CITY OF CANNON BEACH

WATER RESILIENCY PHASE 1 – SEISMIC IMPROVEMENTS

ADDENDUM TO ITB - 4

DATE: August 28, 2023

SITE & EROSION CONTROL PLAN -
NORTH RESERVOIR

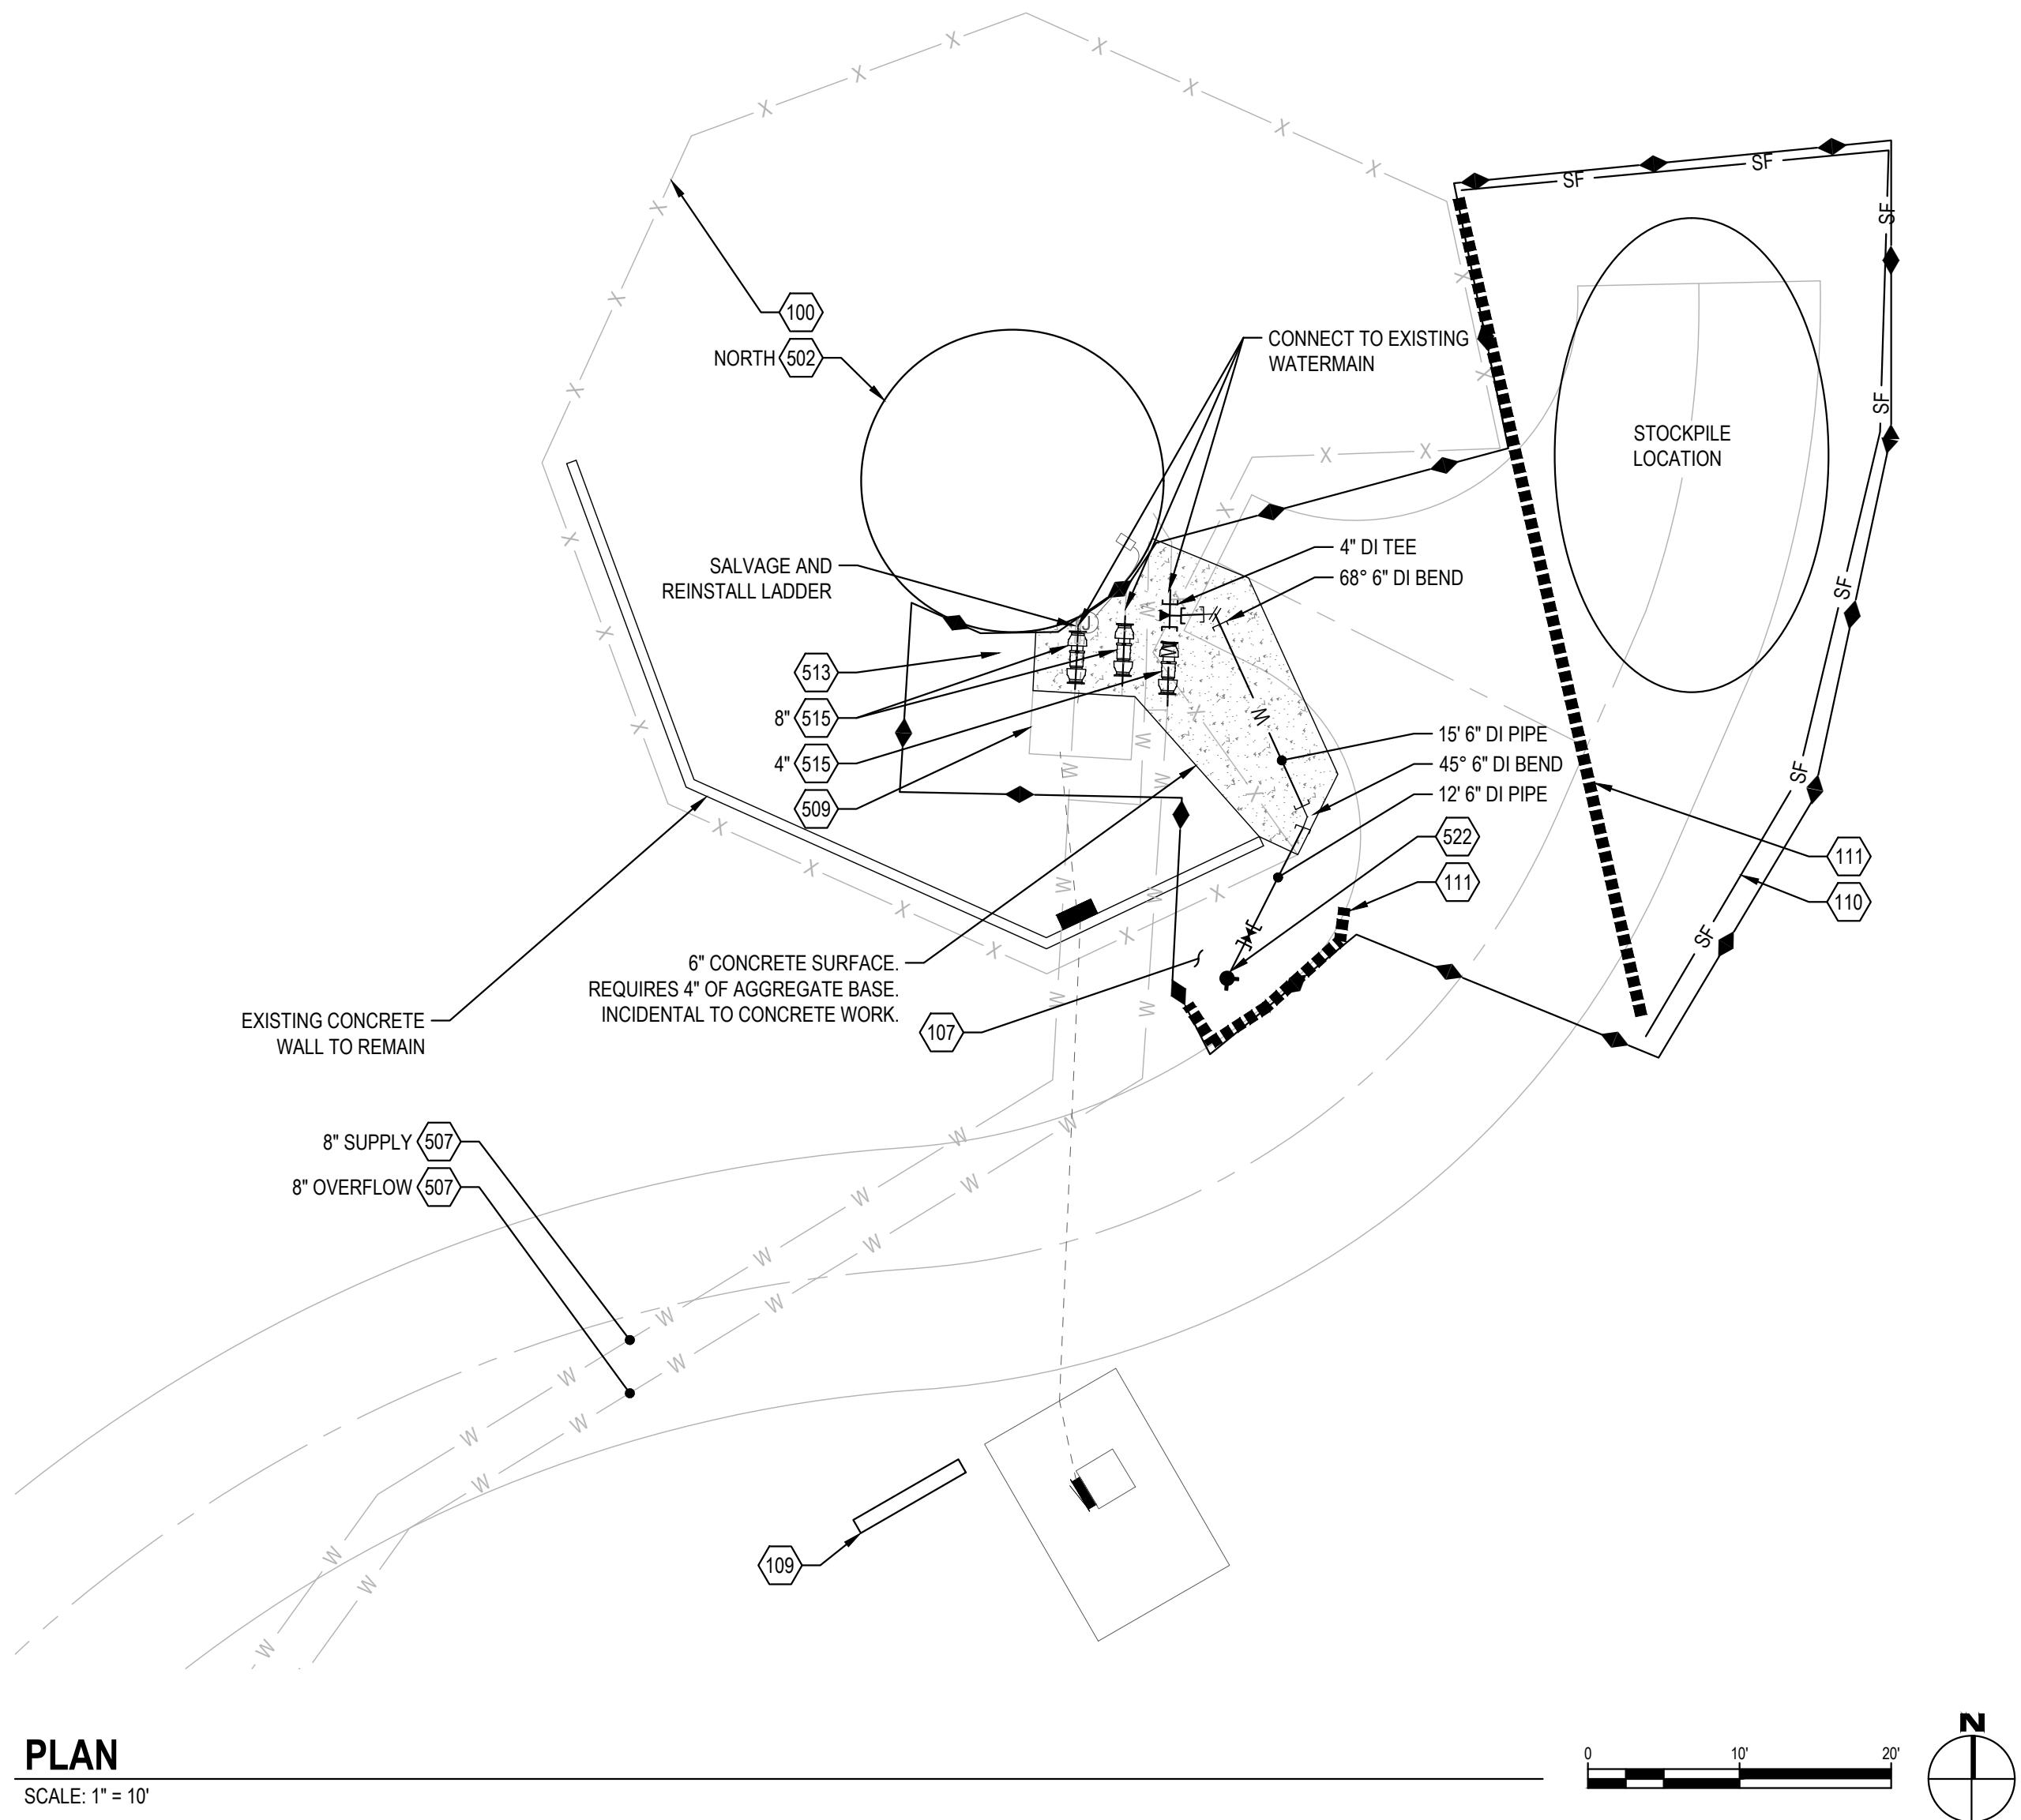
- C102
 - General Notes
 1. City, contractor, and engineer to have a meeting to discuss coordination, responsibilities, and limitations related to water shutdowns.

- Added North Reservoir Shut Down Notes:
 1. Provide the city one week notice before requiring water shut down to perform work.
 2. City will be able to drain the north reservoir prior to connection work.

3. Contractor shall minimize the shutdown to no more than 8-hour window. The shutdown window will need to be overnight during a weekday.

4. The city will refill the tank upon completion of the work performed during the shutdown period.
- C103 Added “Or approved equal” to actuator, valve, and flex-tend detail.

1. PROVIDE THE CITY ONE WEEK NOTICE BEFORE REQUIRING WATER SHUT DOWN TO PERFORM WORK.
2. CITY WILL BE ABLE TO DRAIN THE NORTH RESERVOIR PRIOR TO CONNECTION WORK.
3. CONTRACTOR SHALL MINIMIZE THE SHUTDOWN TO NO MORE THEN 8-HOUR WINDOW. THE SHUTDOWN WINDOW WILL NEED TO BE OVERNIGHT DURING A WEEKDAY.
4. THE CITY WILL REFILL THE TANK UPON COMPLETION OF THE WORK PERFORMED DURING THE SHUTDOWN PERIOD.
